Nº 144 SERVICE BULLETIN

DATE: December 9, 2003

SUBJ: The Lord of the Rings™
Spanish Display & Speech Available

► CPU/Sound Bd. II w/ATMEL

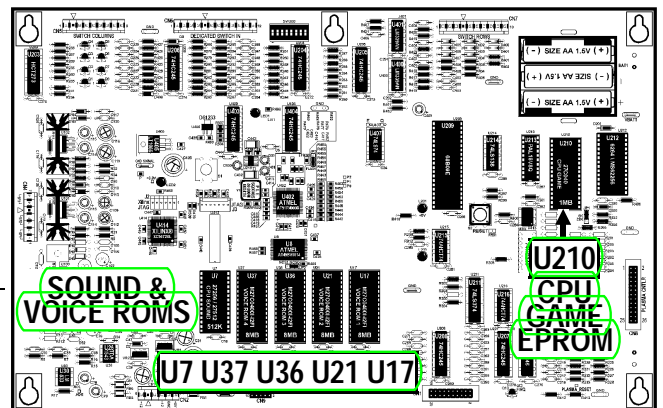
Order the **LOTR Spanish ROM Kit Set** (SPI Part Number **502-5020-00**) from your local distributor (listing in your Manual or on our website). If you have a ROM Burner, you can also download it from our website via www.sternpinball.com/techsupport.htm and click **ROM CODE LIBRARY** (then click *The Lord of the Rings™*). **Replace the following ROMS on your CPU Sound II & Display Controller Boards in the Backbox:**

ROM Name	Chip Size	Program Part Nr.	Version and/or Checksum	Board Name	Board Location
SOUND	512K	965-0401-80L	SP LOTR \$6896	CPU SND II	U7
CPU GAME	1MB	965-0402-80L	v4.01L / \$04FF	CPU SND II	U210
VOICE 1	8MB	965-0403-80L	v1.00 SP LOTR \$DFD0	CPU SND II	U17
VOICE 2	8MB	965-0404-80L	v1.00 SP LOTR \$A4BC	CPU SND II	U21
VOICE 3	8MB	965-0405-80L	v1.00 SP LOTR \$7EE7	CPU SND II	U36
VOICE 4	8MB	965-0406-80L	v1.00 SP LOTR \$1201	CPU SND II	U37
DISPLAY	4MB	965-0407-80L	v4.03L / \$FA7B	Display Controller	U5 (ROM 0)

Always **POWER THE GAME OFF** when servicing your Pinball Game! **TAKE CARE** WHEN REMOVING EPROMS. ENSURE TOOL USED IS BETWEEN THE ROM AND THE SOCKET. WHEN REPLACING, ENSURE ALL THE PINS ARE LINED UP PROPERLY BEFORE PUSHING THEM DOWN. DOUBLE CHECK TO ENSURE EACH ROM IS SEATED PROPERLY, WITH THE NOTCH SIDE LINED UP IN THE SAME DIRECTION AS THE OTHER ICs ON THE BOARD.
